Updated suggested remedy for i-368

Comment i-368

CI 178B SC 178B.8.3.5 P 891 L 47 # I-368

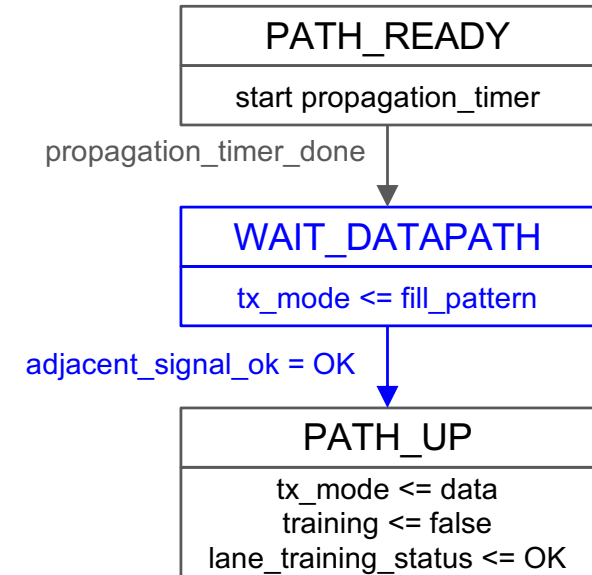
As shown in https://iee802.org/3/dj/public/26_03/slavick_3dj_02_2603.pdf we need to specify the data that transmitted while chip level datapath logic initializes.

Insert a new state "WAIT_DATAPATH" between PATH_READY and PATH_UP. Entry from PATH_READY occurs when propagation_timer_done is true, the exit to PATH_UP occurs when "adjacent_signal_ok = OK" and within the state "tx_mode <= fill_pattern"

In 178B.8.3.1 update tx_mode to add another enumeration fill_pattern: transmits either training frames or local_pattern

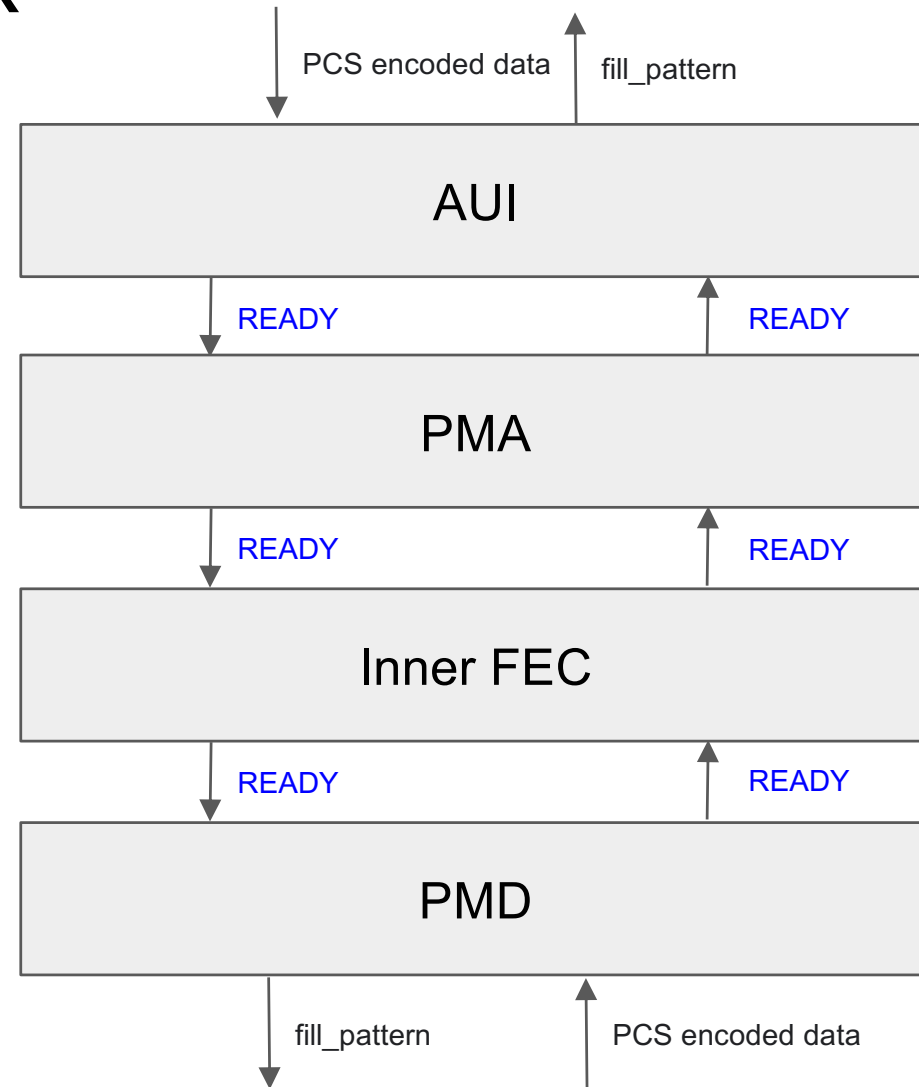
SIGNAL_OK will remain as READY while in this new state. But we're waiting for the Inner FEC or PMA logic to align to the data so that we have "good" data from those layers to transmit. However, the those layers need a value of OK to begin to process the data.

So a retimer/gearbox gets stuck

The AUI component is receiving and providing PCS encoded data to the PMA, however even if its `align_status_demux` is true, it still tells the Inner FEC READY.

Same is true of the Inner FEC telling the AUI component and PMA that we're still in the READY state even though `all_synced` is true.

Comment i-368 updated remedy

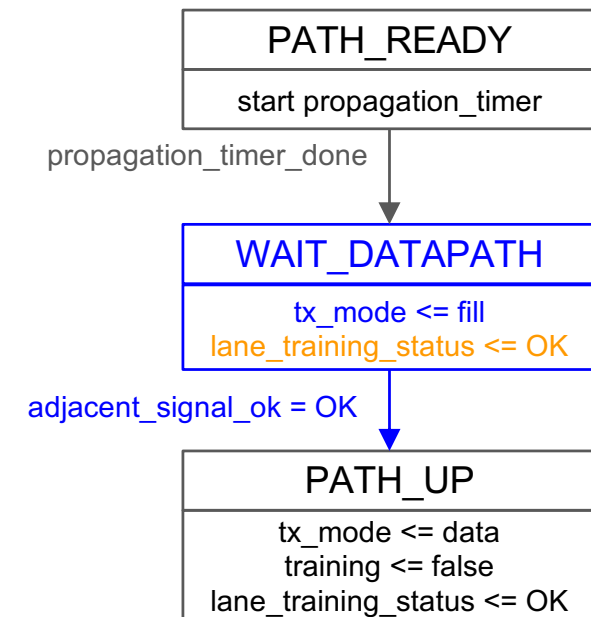
Set the training status to OK in WAIT_DATAPATH so that the Rx indicates it's done and the next layer can begin to parse the data, but we hold the Tx mode change up until we know the data coming in is good to transmit.

Also use fill instead of fill_pattern as we're not defining a new pattern to use but rather options on what pattern to fill with.

tx_mode

Enumerated variable that controls the content of the transmitter output of the lane when tx-disable is false. It is set by the training control state diagram (Figure 178B-10) to one of the values:

- training: transmit training frames (see 178B.7.3)
- local_pattern: transmit a pattern specified by the clause or annex that defines the interface
- fill: transmit either training frames or local_pattern
- data: transmit data from the PMA or Inner FEC
